November 2, 2020

RE: **Lot 2 Block 1 Volcano Cliffs Unit 22 SAD 228
8005 Alto Rey Ct. NW
Grading and Drainage Plan
Engineers Stamp Date 10/29/2020 (D10D003N2)**

PROJECT NAME:
**PETROGLYPH ESTATES
 8005 ALTO RAY CT
 PULTE ID 2**

SHEET TITLE:
**GRADING AND
 DRAINAGE PLAN**

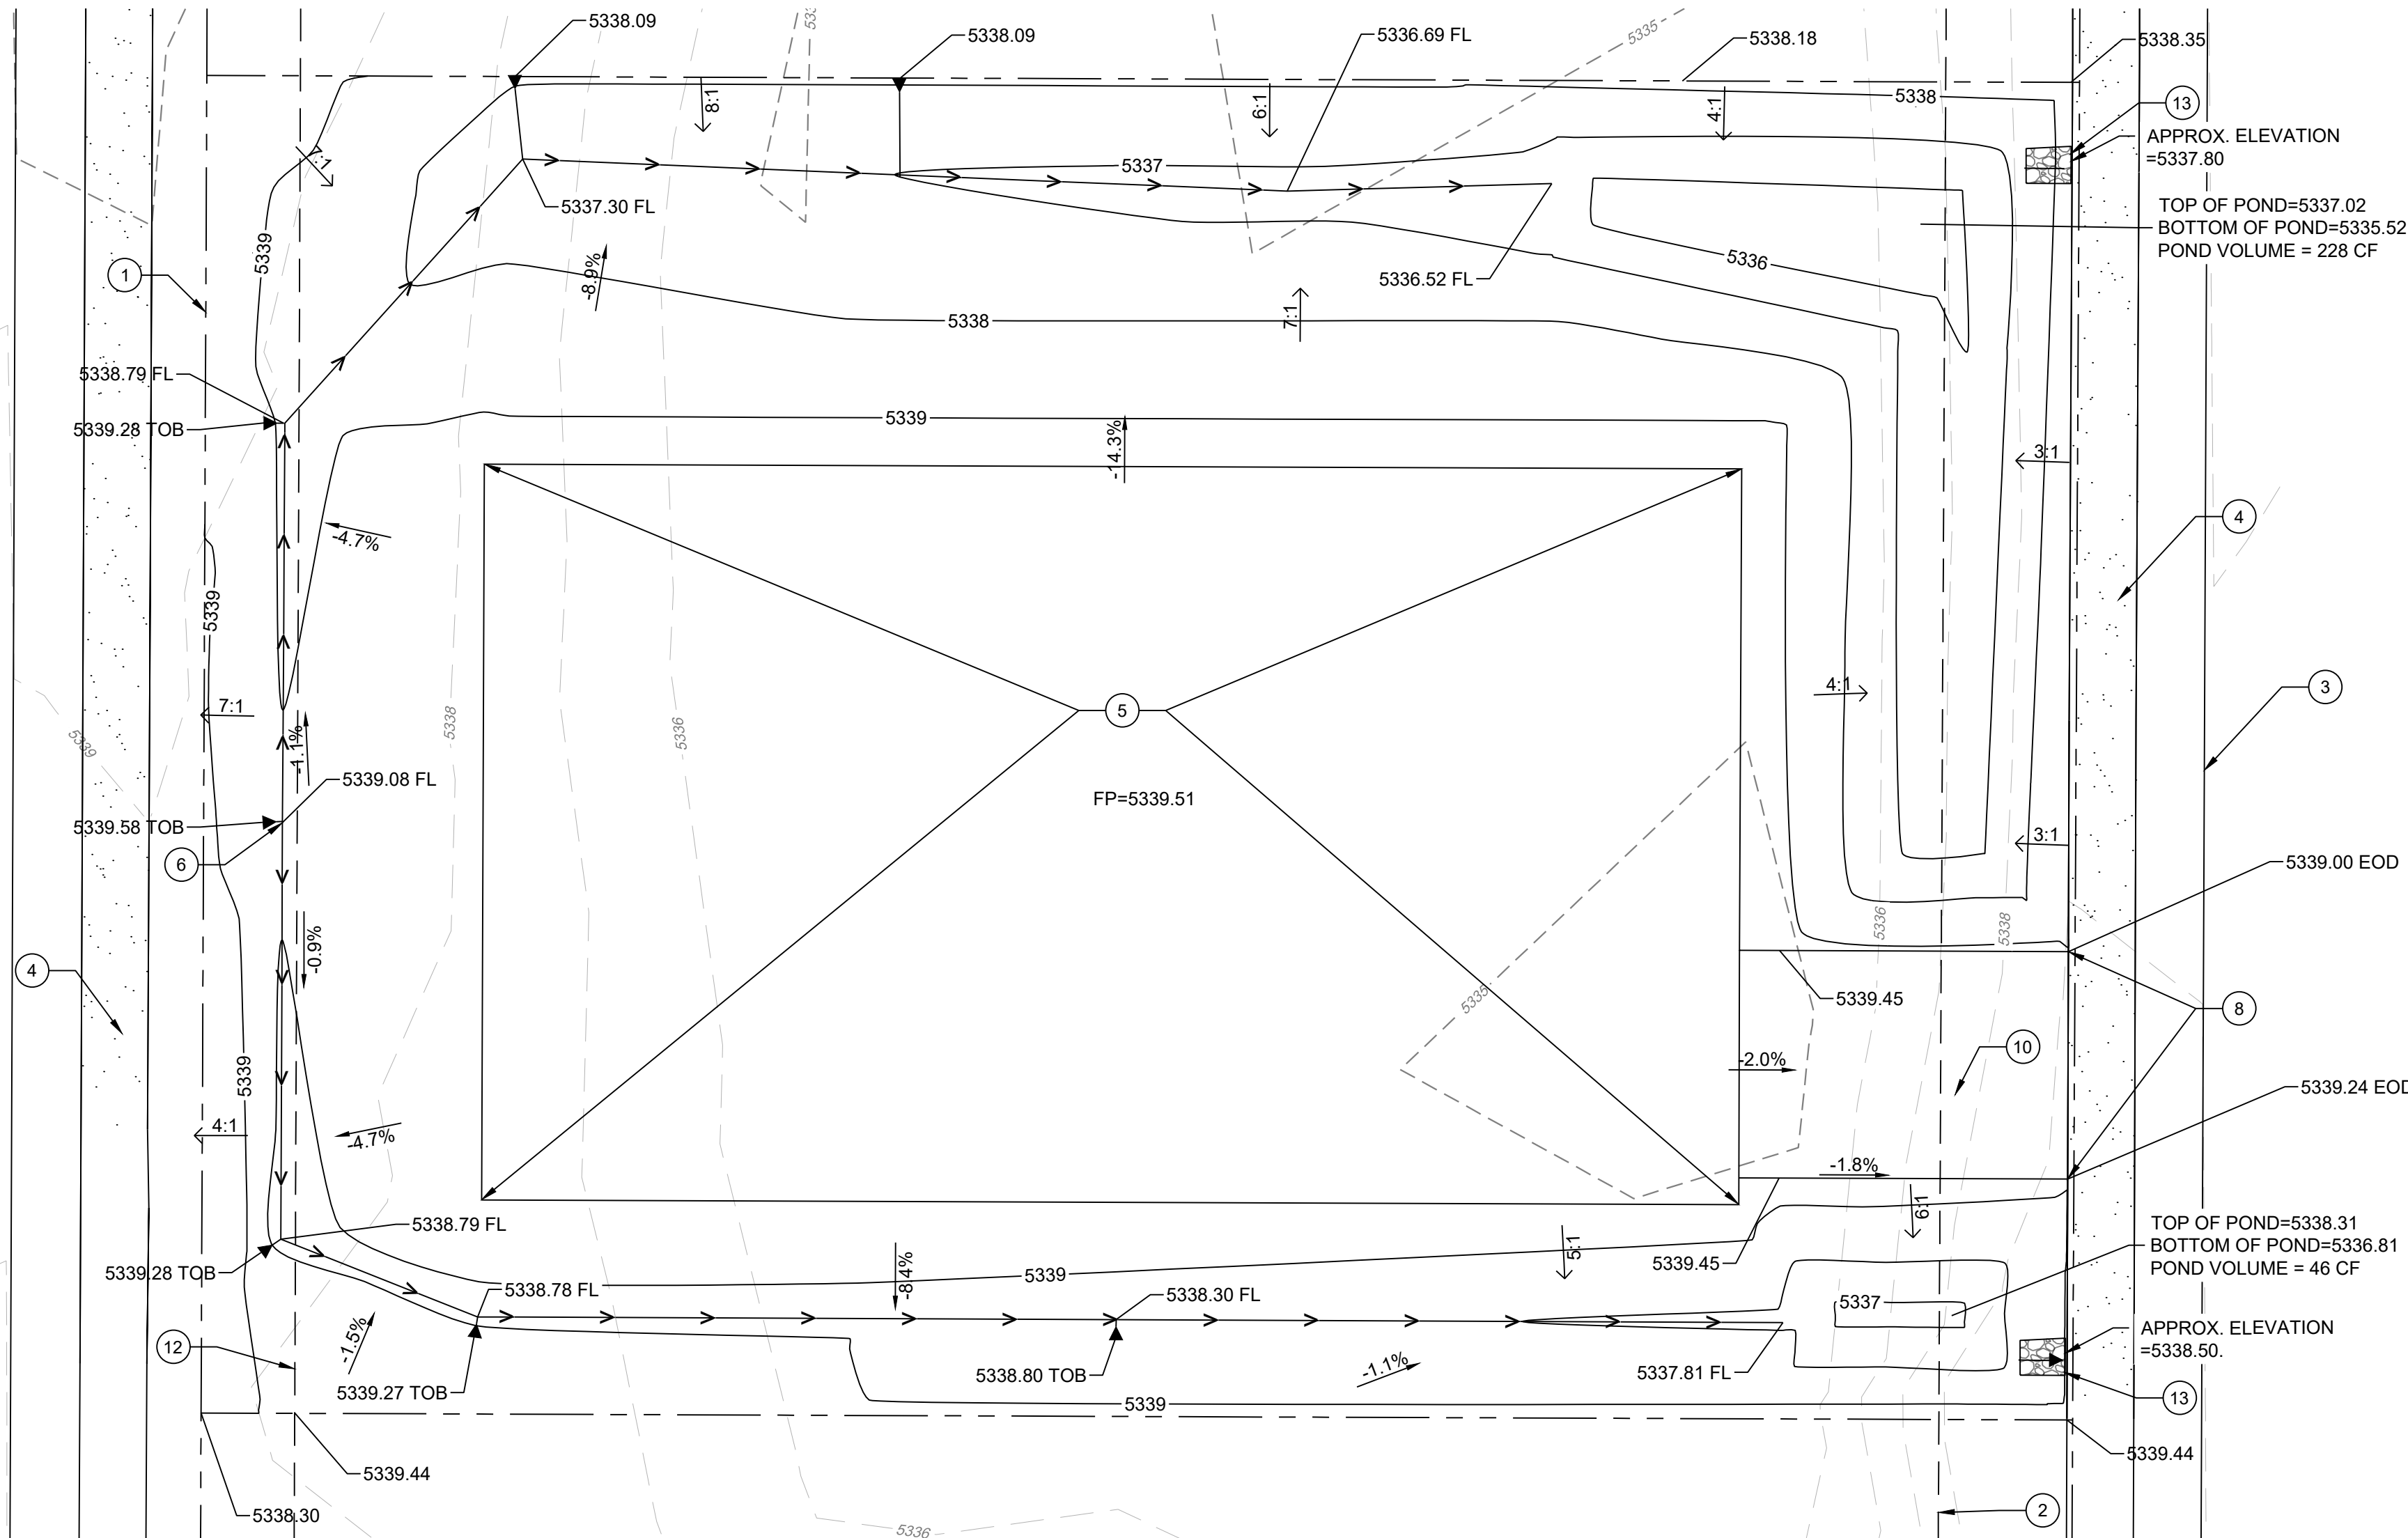
Prior to Building permit approval a Pad Certification will be required, provided by the Engineer or a registered Land Surveyor.

Reiterate to the Owner/Contractor that a separate permit for a garden/retaining wall must be obtained with the approved G&D plan and Pad Certification. **Also, if a swimming pool is to be placed the grading and drainage plan will change and will need to be resubmitted.**

Prior to Certificate of Occupancy release, Engineer Certification per the DPM checklist will be required.
